Memorandum

To: Bassett Creek Watershed Management Commission
From: Barr Engineering Co.
Subject: Item 5A – Consider Approval of 60% Design Plans for 2021 Mt. Olivet Streambank Restoration & Parkers Lake Drainage Improvements Project, Plymouth (CIP 2021 ML-20 and PL-7) -- BCWMC June 17, 2021 Meeting Agenda
Date: June 10, 2021
Project: 23270051.52-2021-644&645

5A Consider Approval of 60% Design Plans for 2021 Mt. Olivet Streambank Restoration & Parkers Lake Drainage Improvements Project, Plymouth (CIP 2021 ML-20 and PL-7)

FIGURE 1

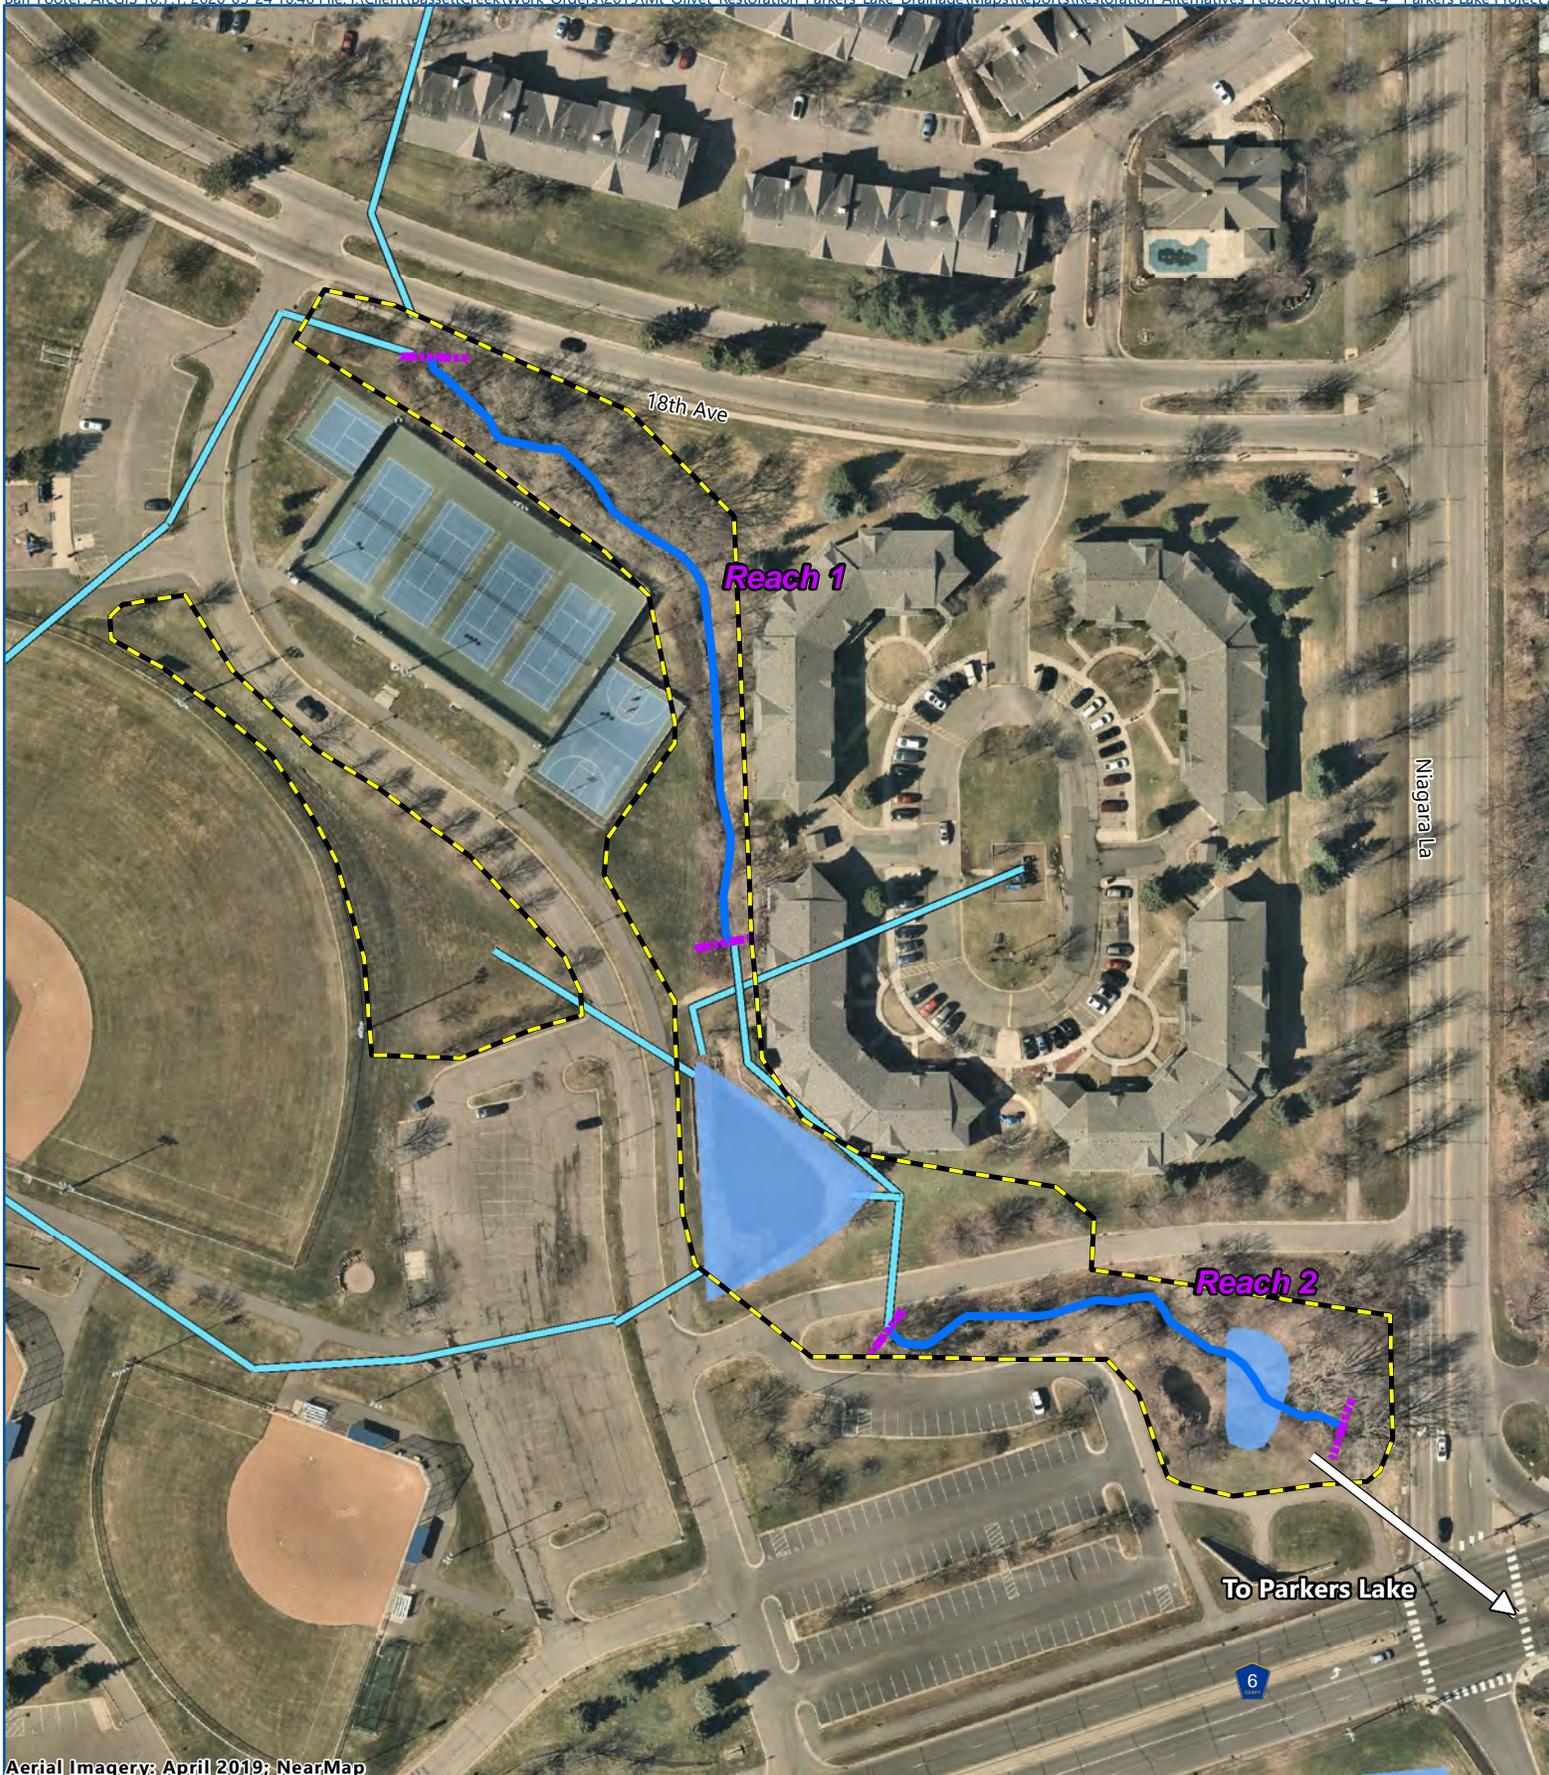
- 2) Comments that apply only to the Mount Olivet Streambank Restoration site:
- a) The plans do not specify any outlet protection or stilling basin at the proposed storm sewer outlet from the Mount Olivet parking lot at station 4+10. We understand from communication with the City that a City-standard outlet protection detail is proposed; please include the standard detail on the plans.

- b) The plans call for widening of the stream channel to eight feet wide from station 7+00 to 9+00; however, a design cross section or proposed channel side slopes are not provided. Please specify a design cross section or side slopes and indicate the extent of the disturbance on the plans.

- c) The plans do not show any downstream erosion control measures at the proposed wetland restoration and access route at the Mount Olivet site (downstream and to the south of the proposed construction areas). Please provide downstream erosion control, such as silt fence or bioroll along the access and at the wetland restoration location.
